British Gliding Association

TNS 10/11/12 /77

- PART I Airworthiness Aggro - (Please add to mandatory list)
- 1.1. ASK. 16 (Motor glider) AD 77-234 and Schleicher Tech. Note 8 requires modification to WHEEL to prevent possible breakage of bolts; (copy herewith).

No. 8

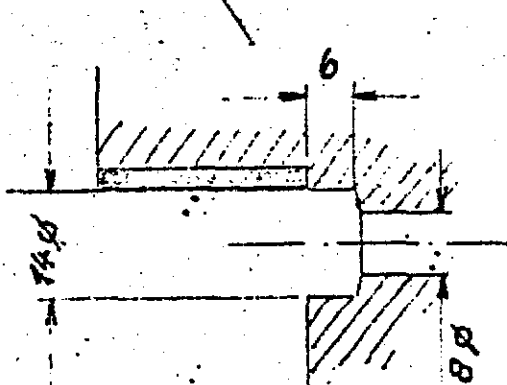
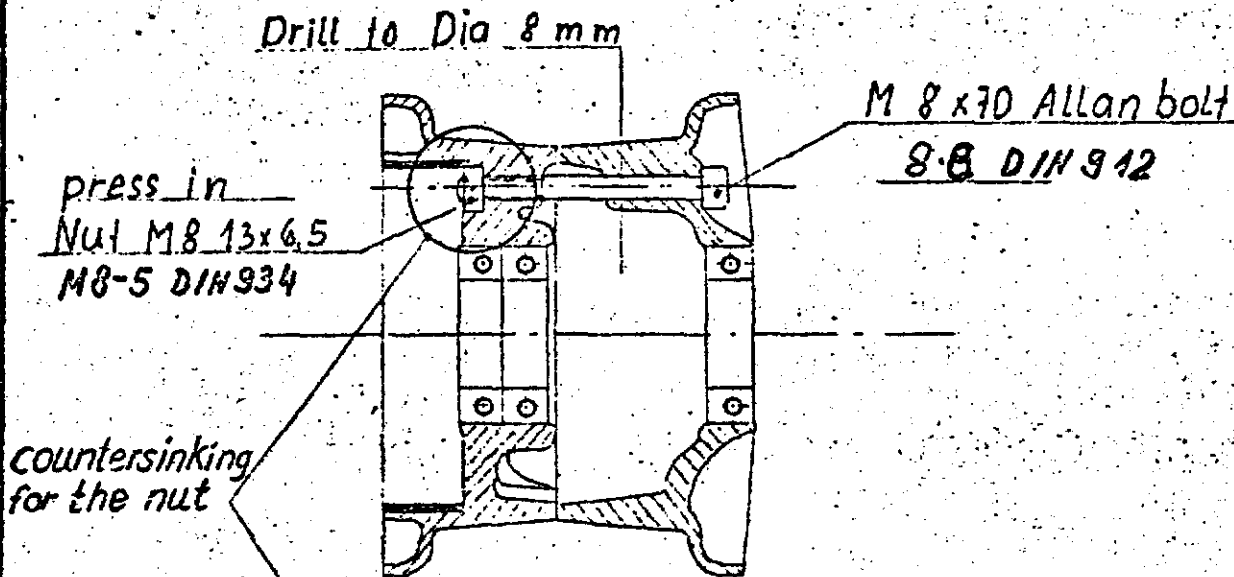
Until December 31, 1977, enlarge holes of wheel hub by drilling and countersinking in accordance with Technical Note No. 8. Replace existing bolts and nuts by Allan bolts M8x70 8.8 DIN 912 and nuts M8-5 DIN 934.

Subject: Enlarging of the bolts at the wheel hub
Effectivity: Powered glider ASK 16
Accomplishment: Changing of the screws
Material: See drawing
Weight and balance: To be neglected

Set drill to
15°

All measures in m.m.

The modification has to be made until **31. Dez. 1977**
 It is recommended to send the hubs to Fa. Tost, 8000 München 2,
 Thalkirchenerstr. 62, Tel. 089-534472 for making the modification.

NIMBUS 15M. BEARING FAILURE

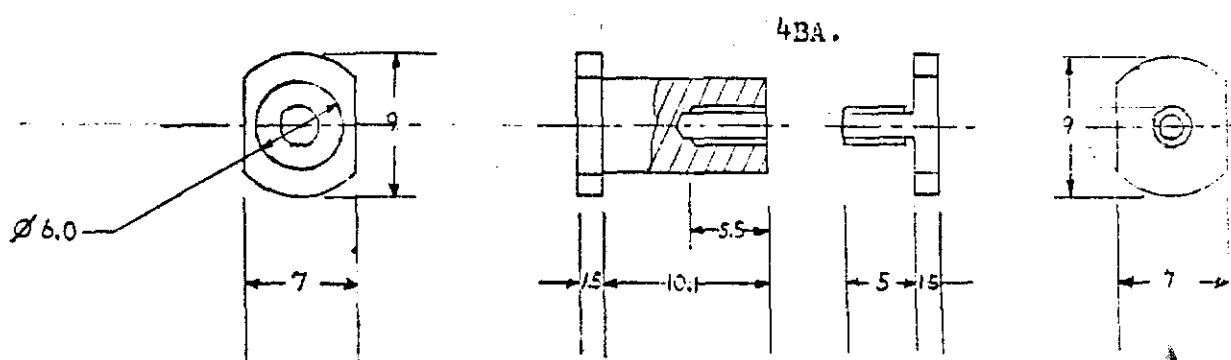
- 1.9. Mini-Nimbus H-S7 (15 metre). Failure of BEARING in air-brake system at bell-crank lever. Attached sketch supplied by I.R. Cook provides repair scheme.

Procedure:- Drill end of bearing mounting shaft off. Discard shaft and remains of bearing. Fit new bearing, retained shim washers and assemble Bolt and Nut using grade A Loctite.

TITLE	BOLT & NUT NIMBUS 15 AIR BRAKE SYSTEM	MATERIAL	S 510	TREATMENT	NIL	FINISH	NATURAL
SCALE	2:1	DIAMENSIONS IN MILLIMETRES (MM)	DRG NO	HS7 No1			
		TOLERANCES ± 0.05
